PCI-SIG ENGINEERING CHANGE NOTICE

TITLE:	Multicast
DATE:	December 14, 2007; approved by PWG May 8, 2008
AFFECTED DOCUMENT:	PCI Express Base Specification version 2.0
SPONSORS:	Hewlett-Packard, Integrated Device Technology, PLX Technology, NextIO, Tundra Semiconductor

Figure 6.xx: Segmentation of the Multicast Address Range

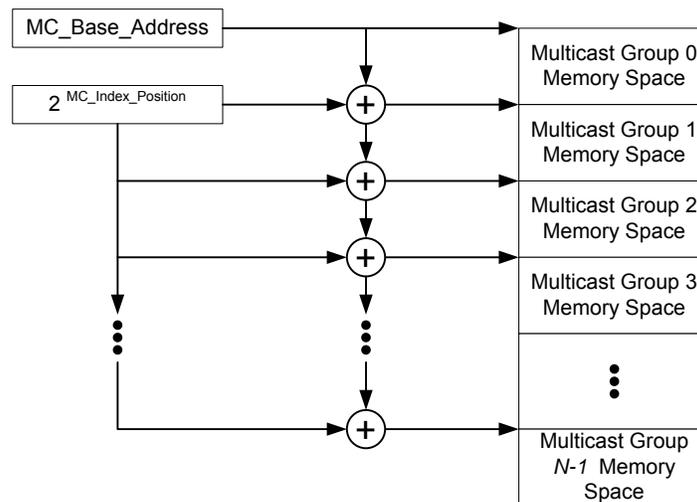
The Multicast Capability structure defines a Multicast address range, the segmentation of that range into a number, N, of equal sized Multicast Windows, and the association of each Multicast Window with a Multicast Group, MCG. Each Function that supports Multicast within a component implements a Multicast Capability structure that provides routing directions and permission checking for each MCG for TLPs passing through or to the Function. The Multicast Group is a field of up to 6 bits in width embedded in the address beginning at the MC Index Position, as defined in section 7.xx.4.

Figure 7-32 Uncorrectable Error Status Register

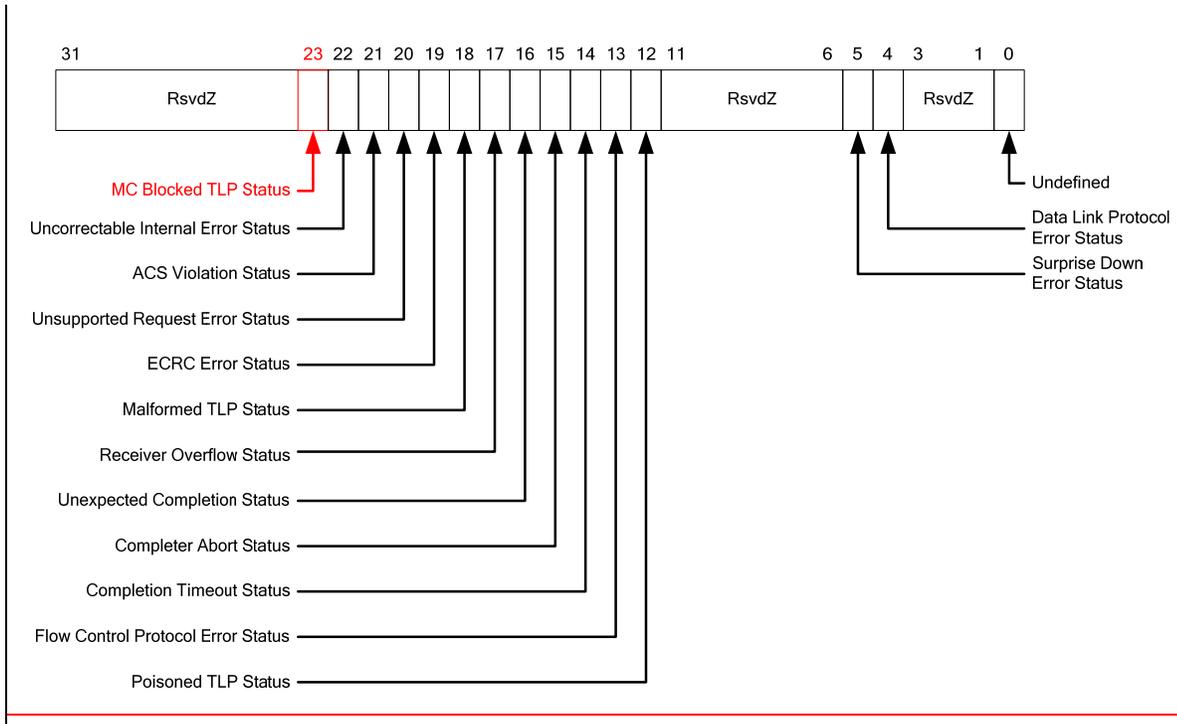
Modify Figure 7-32 and Table 7-29

Bit Location	Register Description	Attributes	Default
...
<u>23</u>	<u>MC Blocked TLP Status (Optional)</u>	<u>RW1CS</u>	<u>0b</u>

Figure 7-33: Uncorrectable Error Mask Register

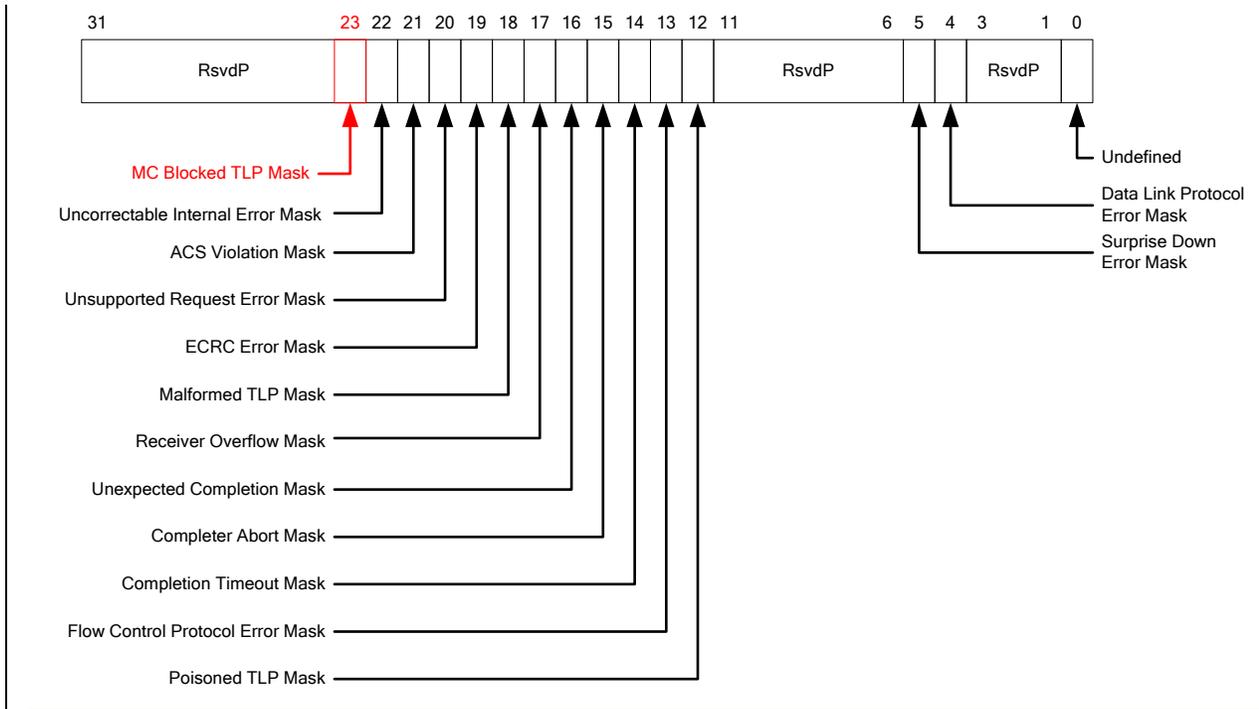
Modify Figure 7-33 and Table 7-30

Bit Location	Register Description	Attributes	Default
...
<u>23</u>	<u>MC Blocked TLP Mask (Optional)</u>	<u>RWS</u>	<u>0b</u>

Figure 7-34: Uncorrectable Error Severity Register

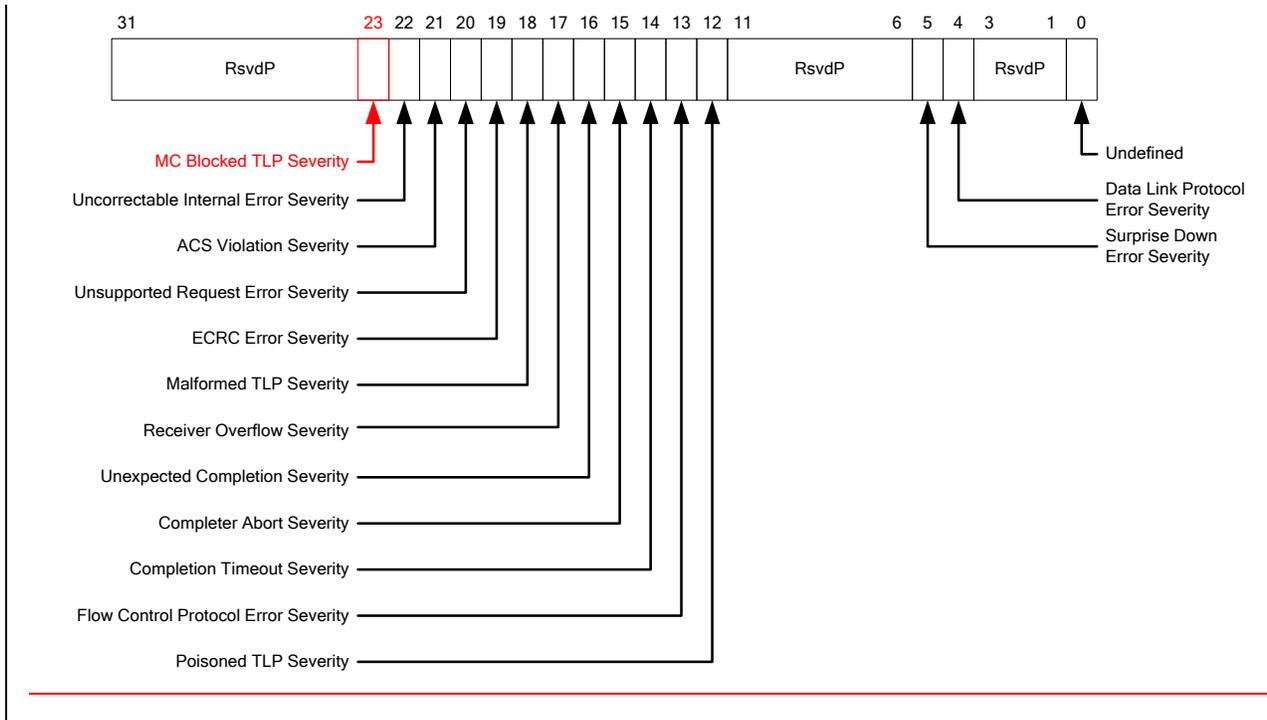
Modify Figure 7-34 and Table 7-31

Bit Location	Register Description	Attributes	Default
...
23	MC Blocked TLP Severity (Optional)	RWS	0b
